Delegated Report		Analysis sheet		Expiry Date:	03/05/2018
(Members Briefing)		N/A / attached		Consultation Expiry Date:	01/12/2019
Officer			Application Number(s)		
Laura Hazelton			2017/6978/P		
Application Address			Drawing Numbers		
Land at 152 Royal College Street London NW1 0TA			Please refer to decision notice		
PO 3/4	Area Team Signature	C&UD	Authorised Officer Signature		
Proposals					
Erection of 4 storey building including excavation of basement to provide 1 x 3 bedroom flat and 1 x 2 bedroom live/work unit.					
Recommendation(s):		Grant conditional planning permission subject to S106 agreement			
Application Type:		Full Planning Permission

Application Ref: **2017/6978/P**

DECISION
Proposal: Erection of a 4 storey building including excavation of basement to provide 1 x 3 bedroom flat (Class C3) and 1 x 2 bedroom live/work unit (Sui Generis).

Photo1: Visualisation of proposal

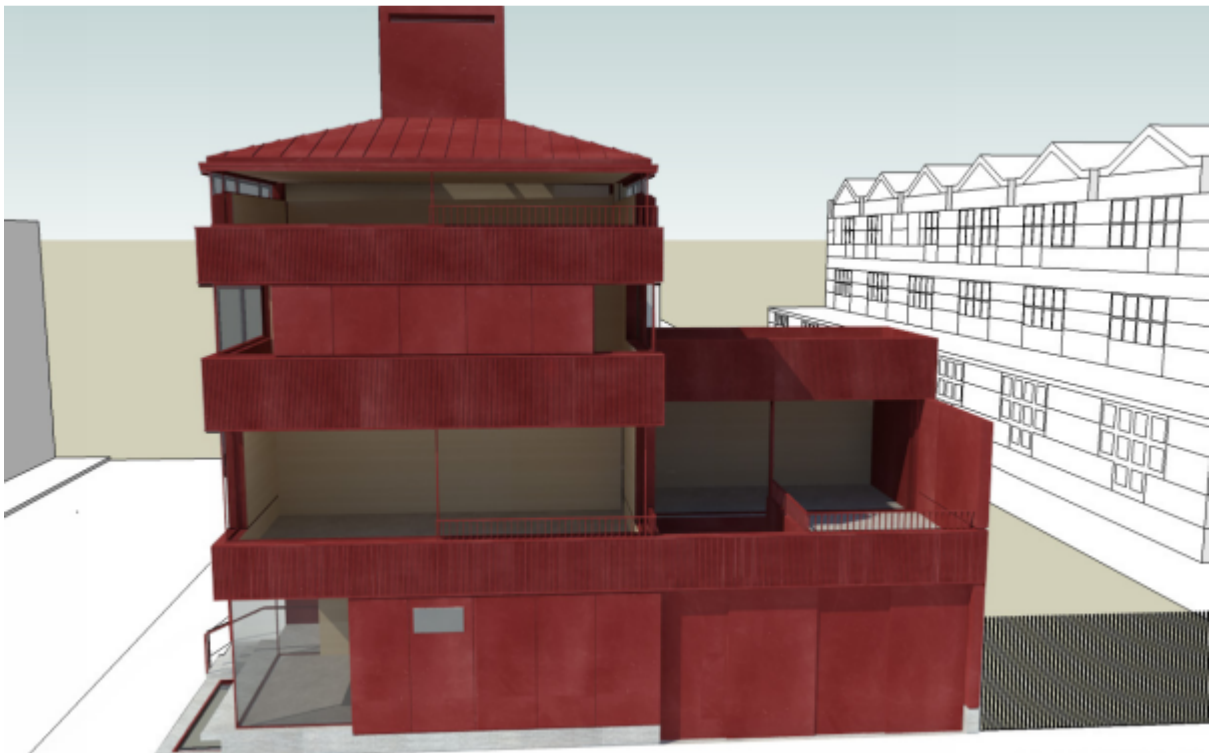
- 1.3 The applicant is now proposing to amend the cladding material to a red corrugated metal. The reason for the amendment, as set out in the applicant's Design and Access Statement is four fold:

- 3.2 The previously proposed rust coloured concrete would be replaced with an oxide red coloured metal cladding, which would be constructed and placed to retain the horizontal banding of the proposed building which was designed to pick up on the rhythms of the adjoining historic terrace.

- 3.4 The main visual difference will be in the exterior appearance of the building. The Council was supportive of the previously proposed concrete finish which would have resulted in a strong, modern, sculptural presence in this location. A dominant characteristic of the building was the unbroken horizontal banding which related to the floor slabs of the building, and the vertical panels which picked up on the fenestration rhythm of the adjacent houses. To ensure these two important elements will still be prominent in the metal cladding, it is now proposed to utilise two visually different types of cladding – for the vertical panels, wide cladding panels will be used, and for the continuous horizontal band, vertically corrugated panels will be used which will also help to conceal the joints between panels. Following concerns regarding how the joints between different panels of metal would appear, additional detailed drawings were submitted demonstrating a high standard of design quality. Sample panels and full detailed drawings of the materials and façade junctions would also be secured by condition.

- 3.5 Although the use of oxide-red cladding in this location would be visually dominant, it would retain the successful elements of the previous scheme which were considered to provide a high quality, architecturally interesting, sculptural building. The building would be clearly differentiated as a modern piece of architecture, which references and respects the materials and proportions of the historic neighbouring buildings, and preserves the character of this part of the Conservation Area. The Council has reviewed another scheme from this architectural practice which has utilised the same material in west London and it is considered to provide a high standard of detail and finish, which would be appropriate in this location. The oxide red colour would pick up on the red brick buildings in this area, although full details of the proposed material, joins, colour and finish would be secured by condition to ensure a high standard of design and material.
